Addendum # 2 Bid 20-99433 Project: #1875 – Public Works & Utilities Building Roof Replacement

ADDENDUM No. 2

- A. Project Name: Public Works & Utilities Building Roof Replacement.
- B. Owner: City of Duluth, Minnesota.
- C. Architect: Benjamin Olson, AIA.
- D. Architect Project Number: 17790.000.
- E. Date of Addendum: June 29, 2020.

COVER SHEET

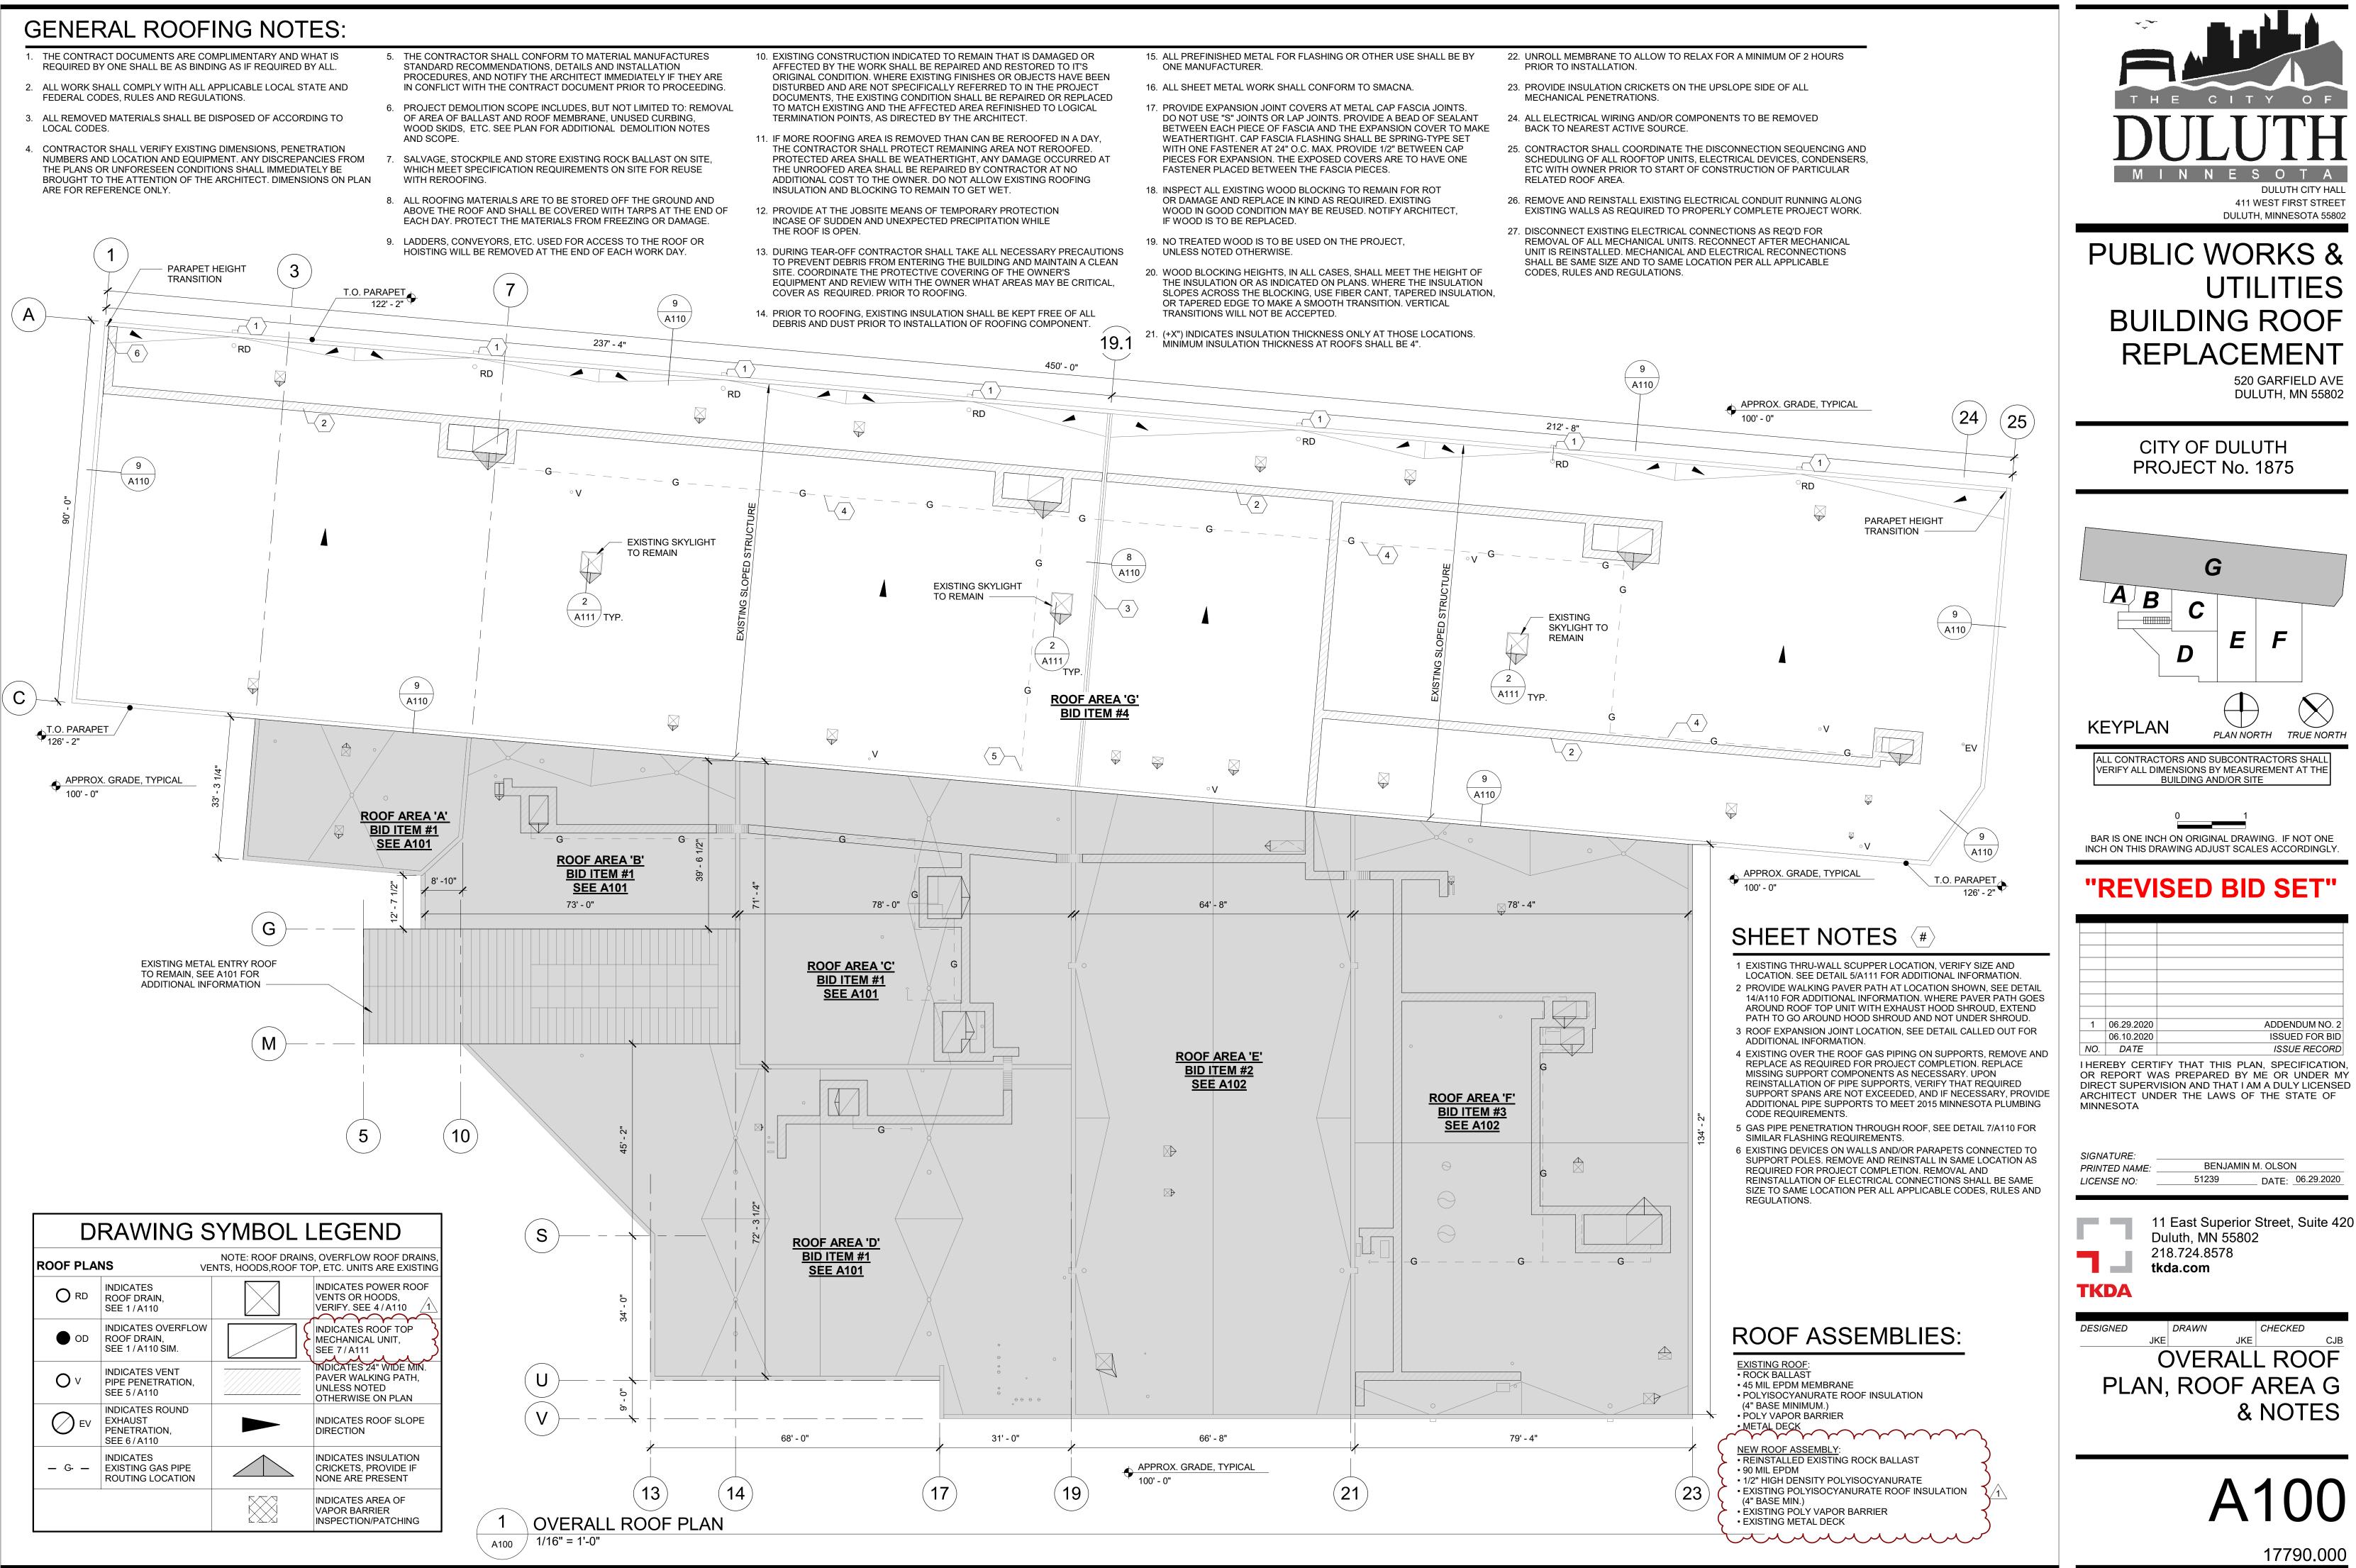
- A. Sheet G000 Cover Sheet (revised) (reissued).
 - 1. Revised Bid Scope: Add 1/2 inch high density polyisocyanurate to the roof description.
- B. Sheet A100 Overall Roof Plan, Roof Area G & Notes (revised) (reissued).
 - 1. Changed reference detail in legend for mechanical unit to 7/A111 and revised new roof assembly for 1/2 inch high density polyisocyanurate.

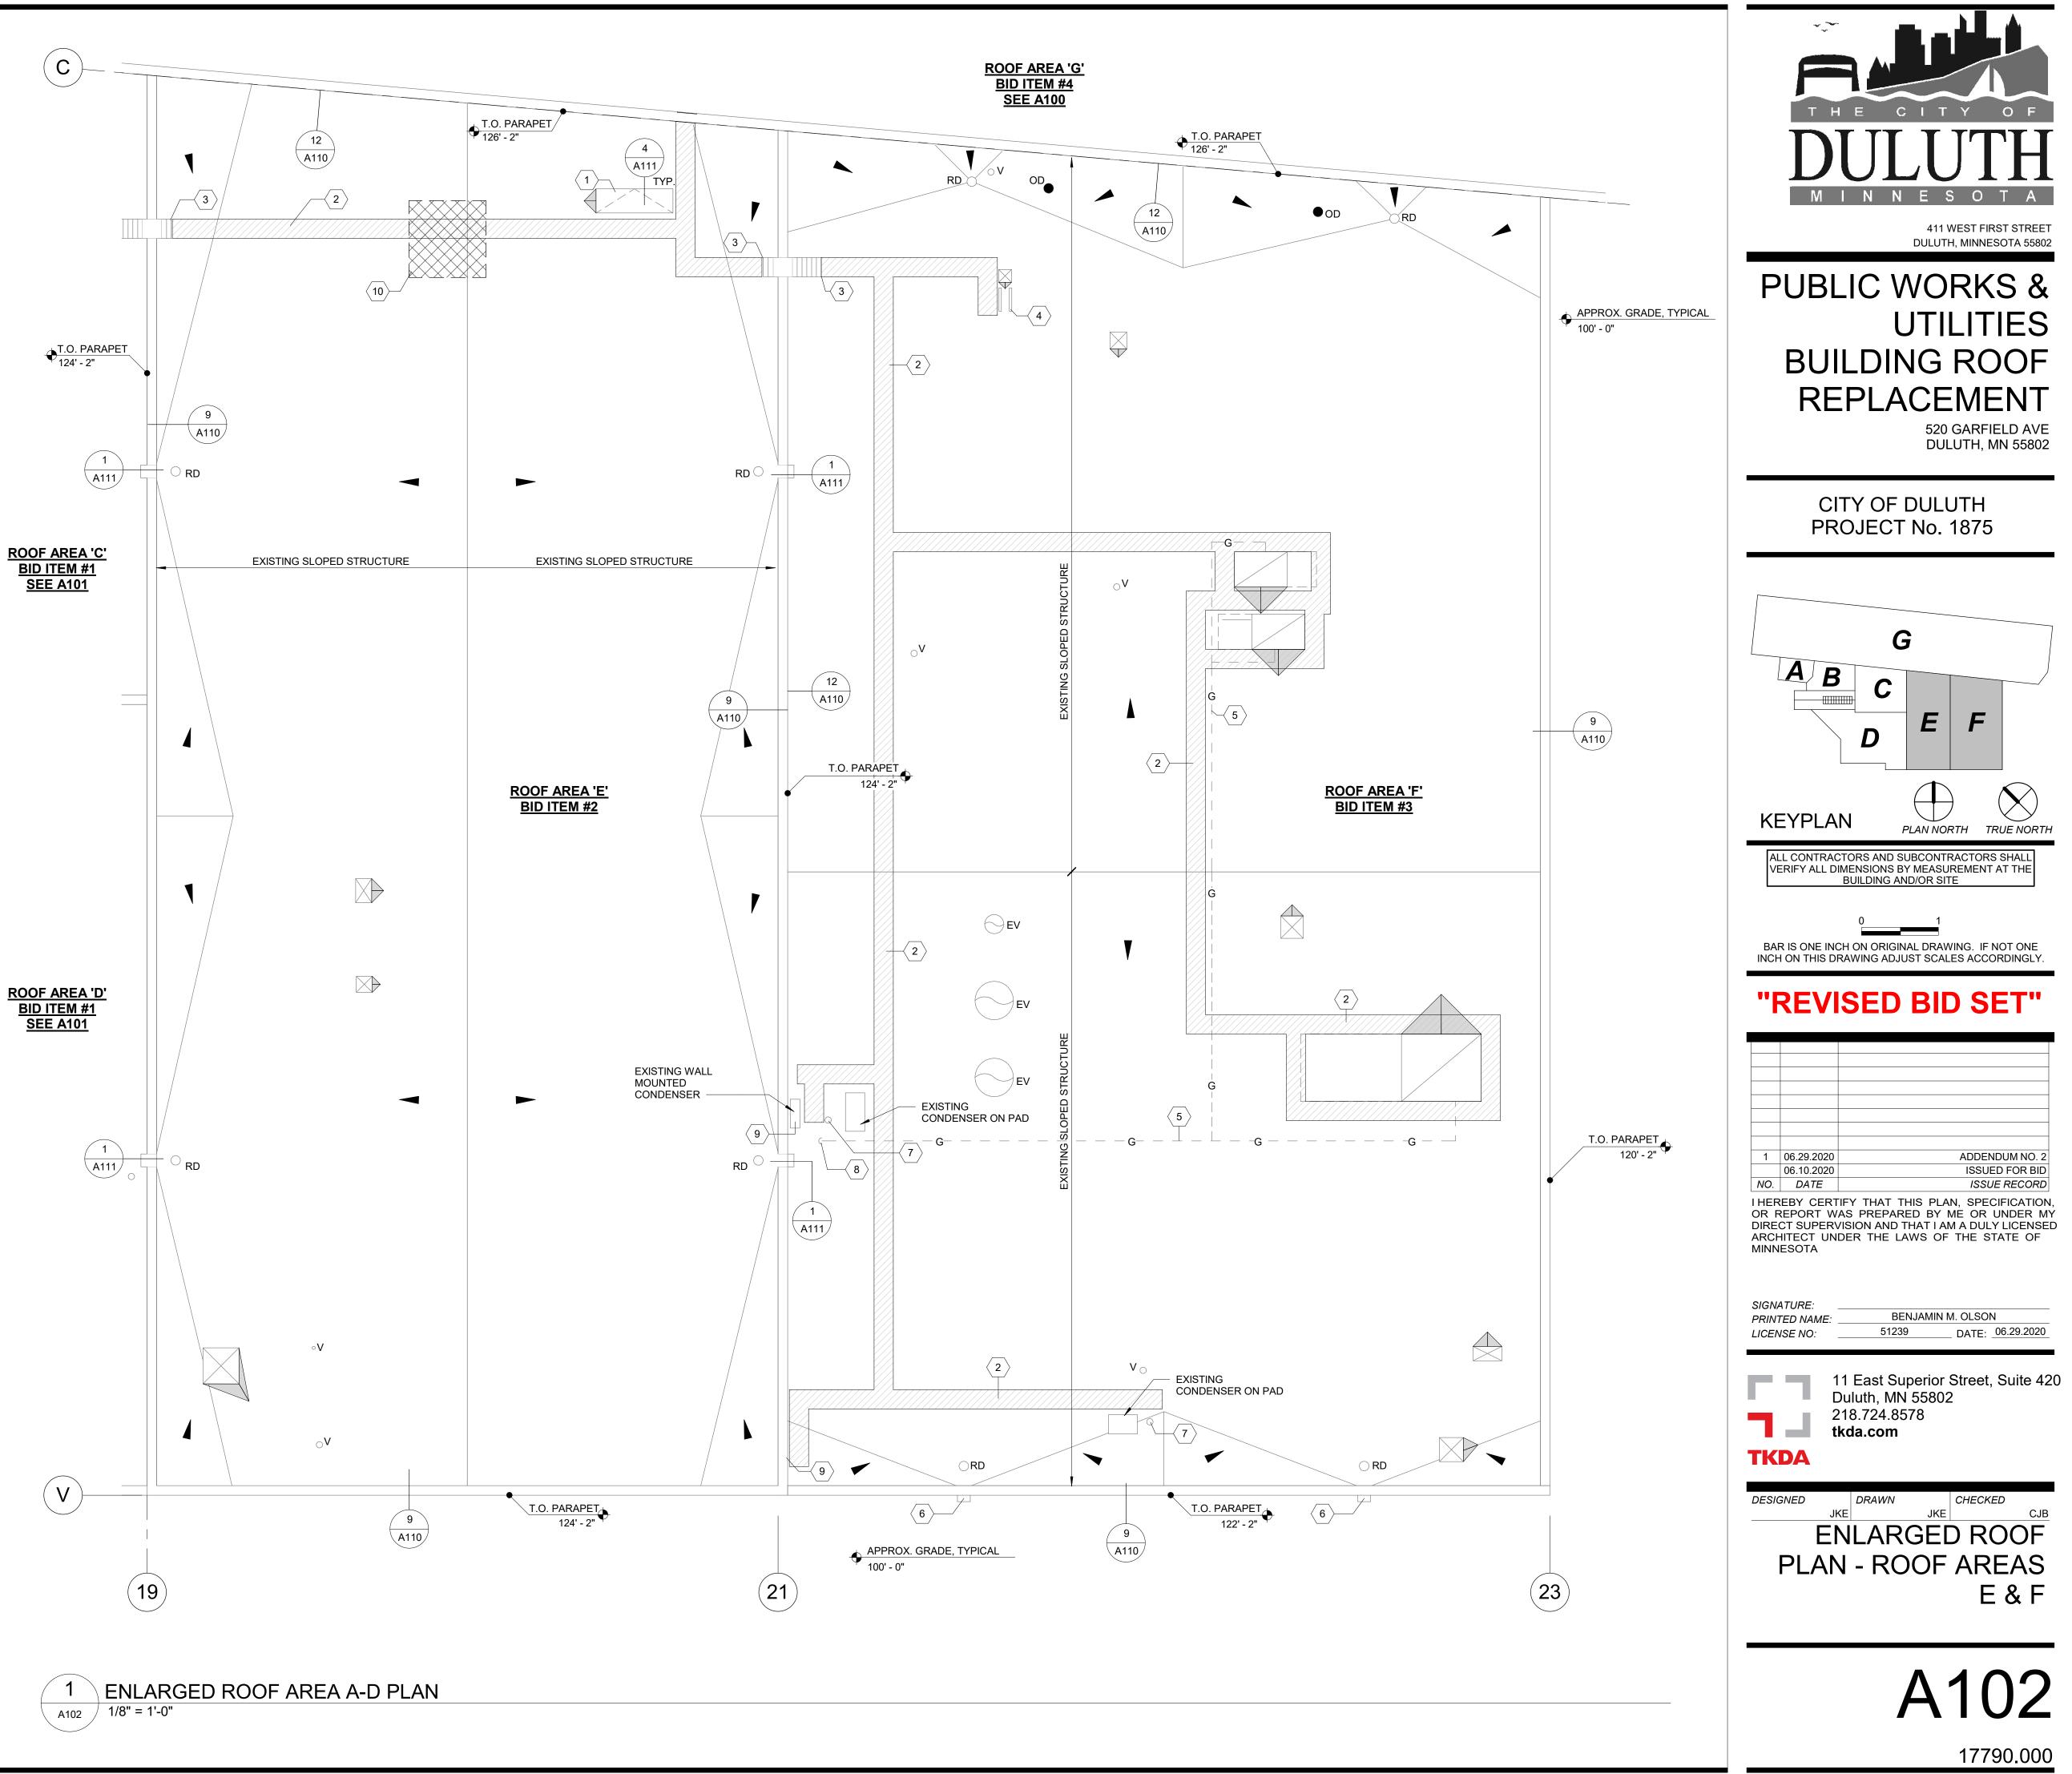
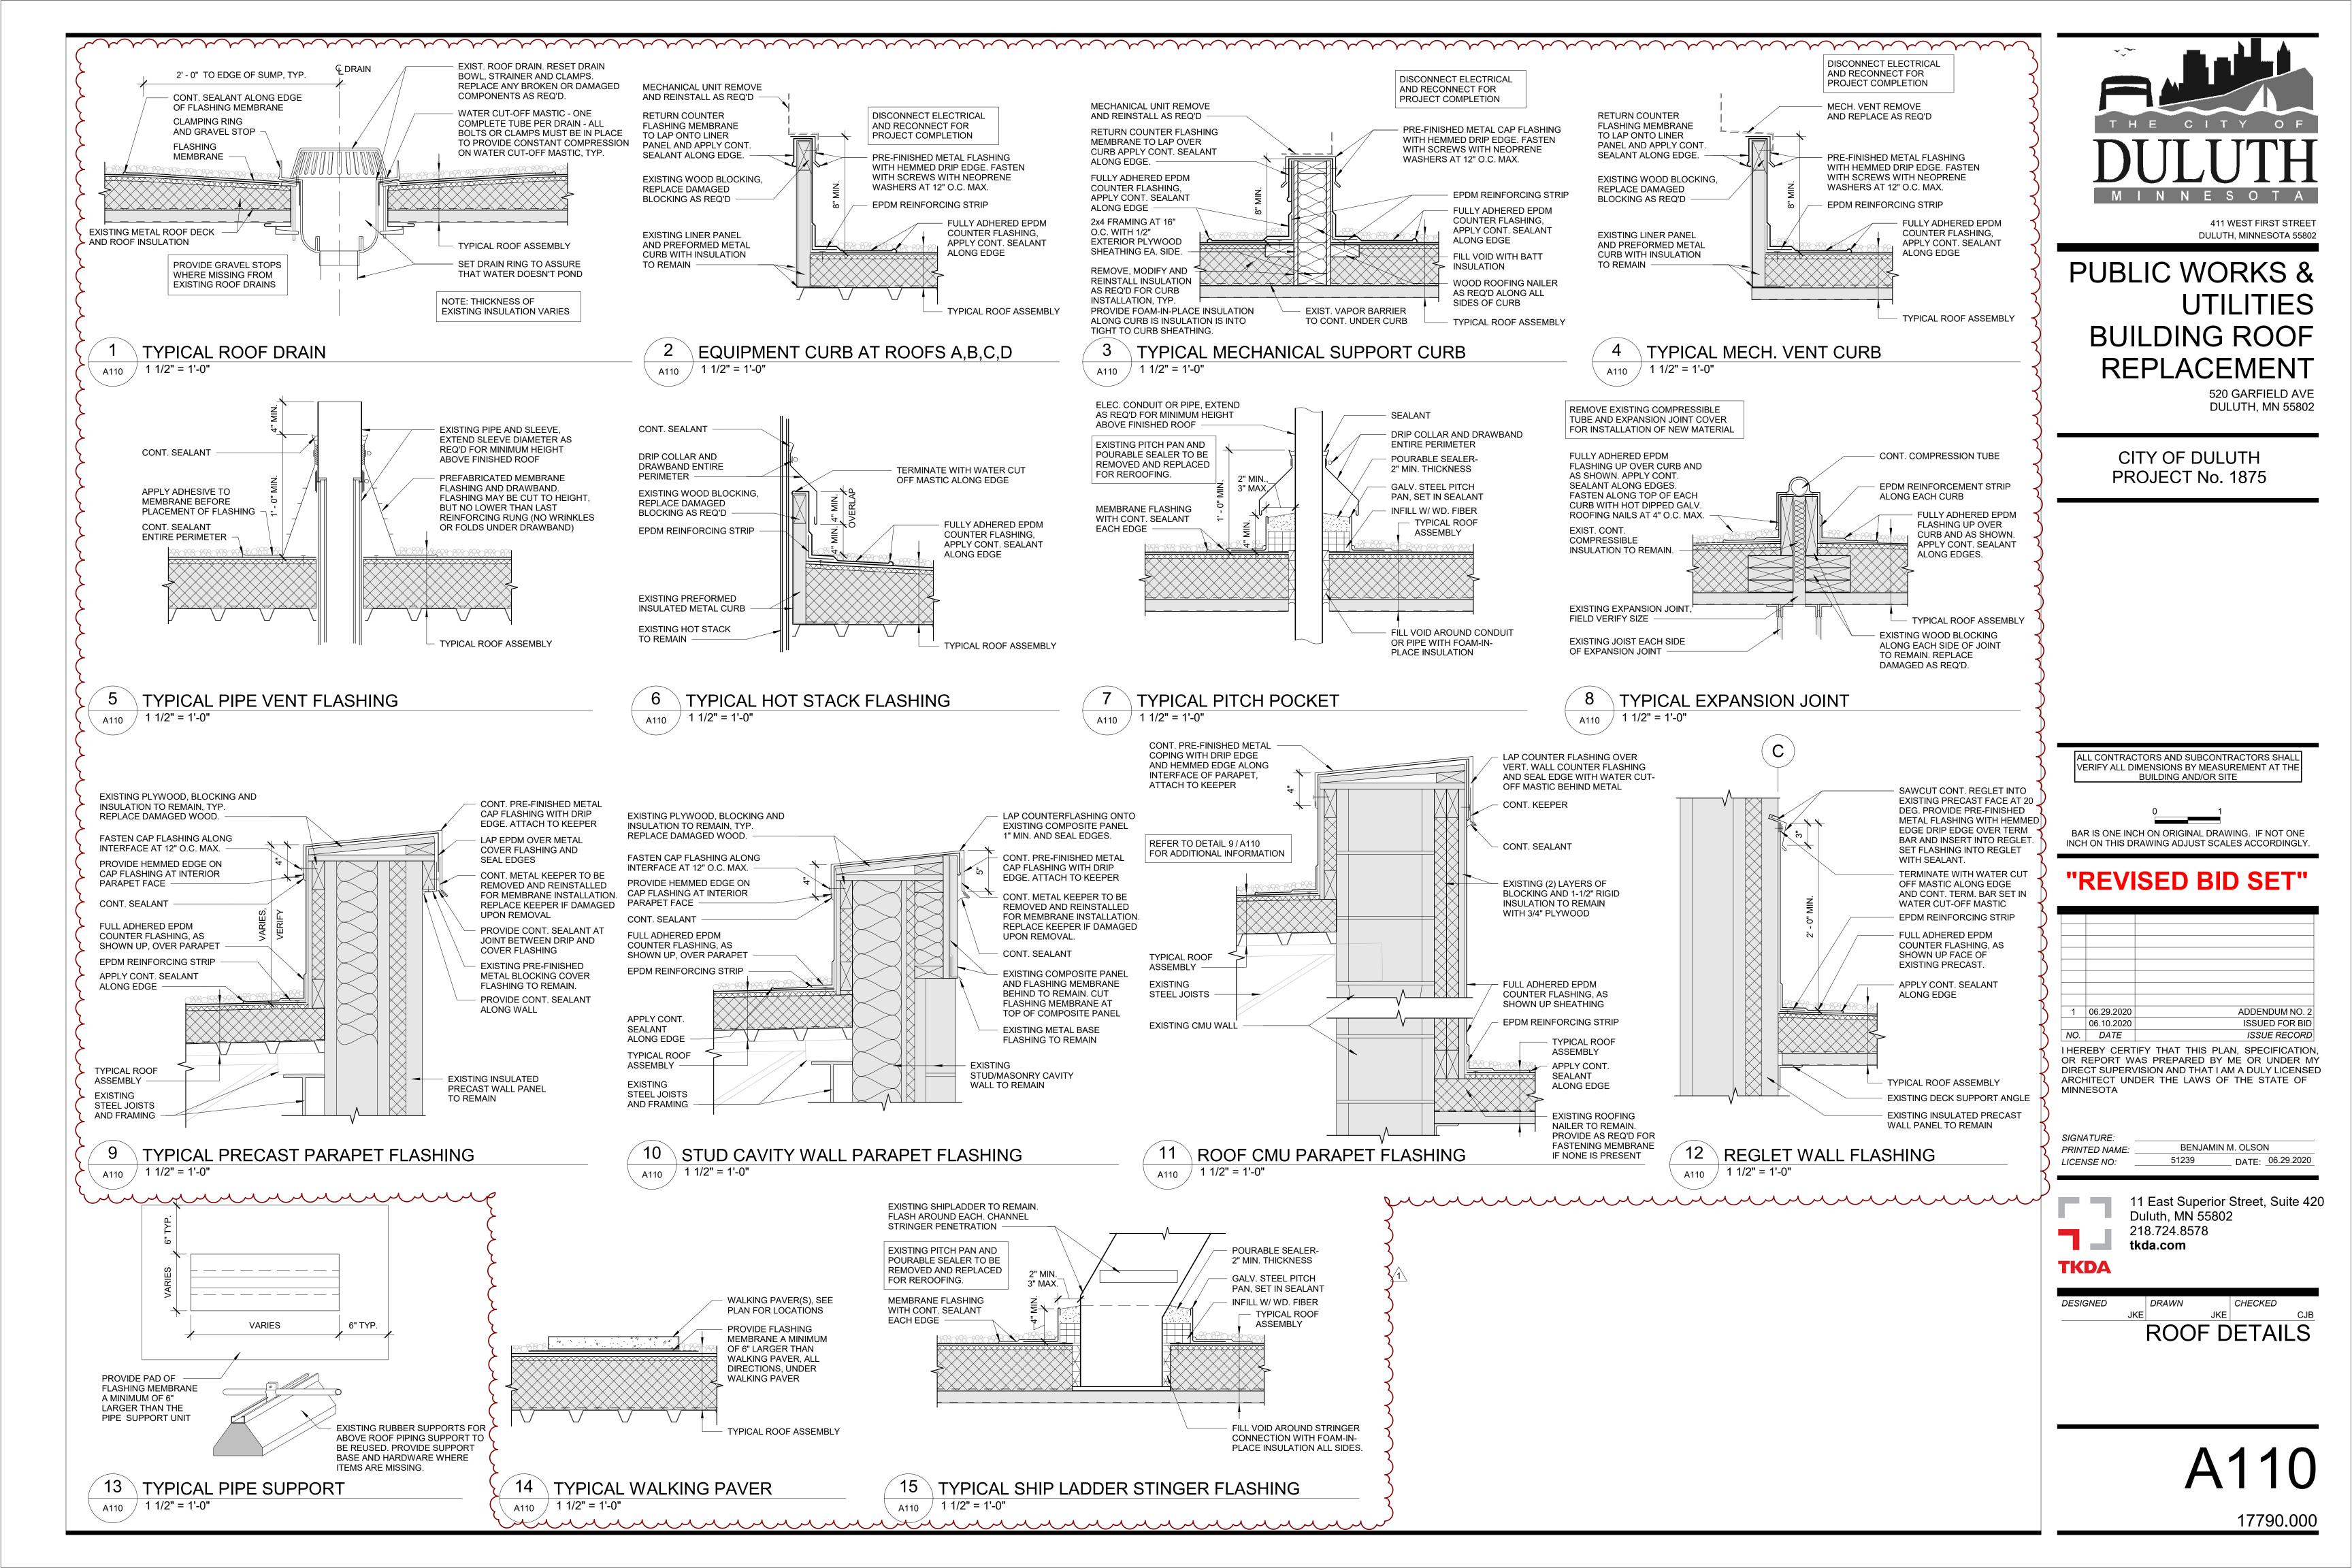
- C. Sheet A101 Enlarged Roof Plan, Roof Areas A, B, C & D (reissued only).
- D. Sheet A102 Enlarged Roof Plan, Roof Areas E & F (revised) (reissued).
 - 1. Changed reference detail in legend for mechanical unit to 7/A111.
- E. Sheet A110 Roof Details (revised) (reissued).
 - 1. Added 1/2 inch high density polyisocyanurate to details,
 - 2. Changed 2/A110 detail name to reference only roofs A,B,C, and D.
- F. Sheet A111 Roof Details (revised) (reissued).
 - 1. Added 1/2 inch high density polyisocyanurate to details.
 - 2. Changed 2/A111 to keep skylight installed during roof replacement.
 - 3. Added detail 7/A111 to keep mechanical unit installed on roofs E,F, and G during roof replacement.
